Subject: SQUEAK NOISE FROM WINDSHIELD WIPER LINK	Bulletin No: 09-010/15
	Last Issued: 03/16/2015

BULLETIN NOTE

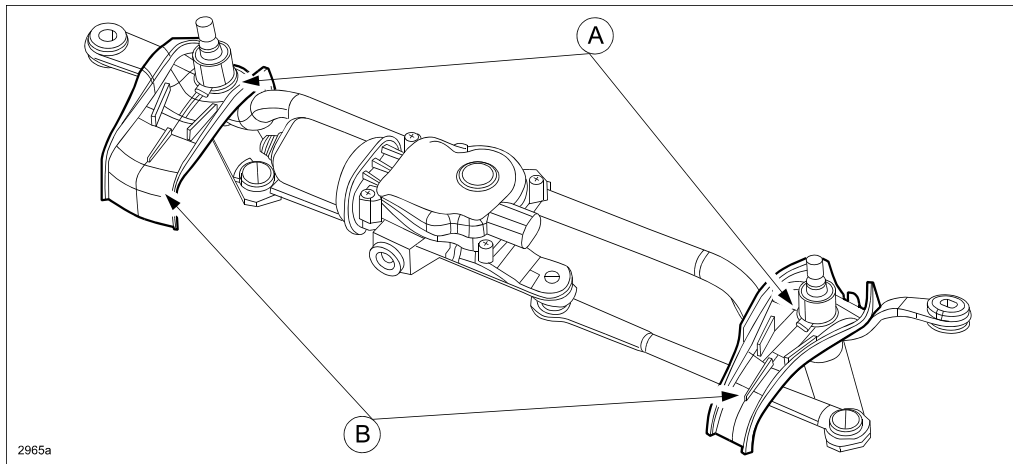
Some vehicles may exhibit a squeaking noise from the windshield wiper link when operating the wipers. This noise may be caused by rust on the sliding parts from water entry through the pivot (A). To prevent water entry, the pivot cover (B) has been enlarged and an O-ring has been added to the pivot.

1. Verify customer concern.
2. If noise occurs when operating the wipers, replace the windshield wiper link assembly with a modified one. Refer to the instructions on MS3 online or the Workshop Manual (section 09-10 WINDSHIELD WIPER MOTOR AND LINK REMOVAL/INSTALLATION).
3. Verify repair.
